HISTORIC AND DESIGN REVIEW COMMISSION

HDRC CASE NO: 2023-005
ADDRESS: 719 E CARSON
LEGAL DESCRIPTION: NCB 1261 BLK 29 LOT 19, 20 & S 9.8 FT OF 18
ZONING: R-6, H
CITY COUNCIL DIST.: 2
DISTRICT: Government Hill Historic District
APPLICANT: Stetson Holland/Rhino Roofers and Construction
OWNER: Eugene Walker/EVENT HOLDINGS LLC
TYPE OF WORK: Roof replacement
APPLICATION RECEIVED: January 03, 2023
60-DAY REVIEW: Not applicable due to City Council Emergency Orders
CASE MANAGER: Edward Hall

REQUEST:

The applicant is requesting a Certificate of Appropriateness for approval to replace the existing, asphalt shingle roof with aa metal roofing product that is to appear as historic, wood shake roofing shingles.

DECRA Shake XD Specs

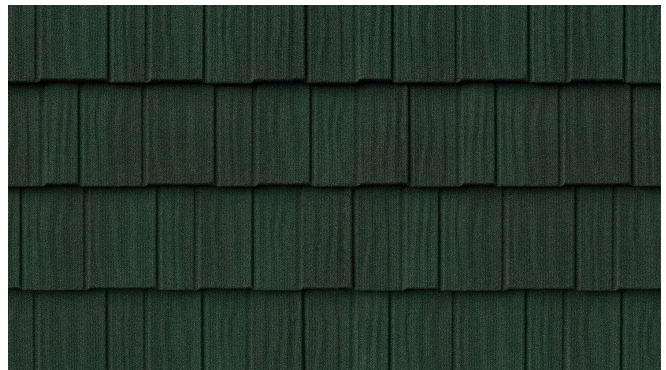
- d. ROOF REPLACEMENT – At this time, the applicant is requesting a Certificate of Appropriateness for approval to replace the existing, asphalt shingle roof with composite roofing product that is to appear as historic, wood shake roofing shingles. The proposed material is supplied in 14” x 52” sheet. The Guidelines for Exterior Maintenance and Alterations 3.A.iv. notes that roofing materials should be replaced in-kind whenever possible. Additionally, the Guidelines recommend that replacement roofing materials should match the original materials in terms of their scale, color, texture, profile, and style, or that materials that are consistent with the building style should be selected. Staff finds that the composite roofing sheets that are to appear as wood shake shingles are not consistent with the Guidelines. Staff finds that in-kind replacement or replacement with a synthetic wood shake would be appropriate.

Staff does not recommend approval based on findings a through d. Staff recommends the applicant replace the roof in-kind, or with a synthetic wood shake that features individual shakes.
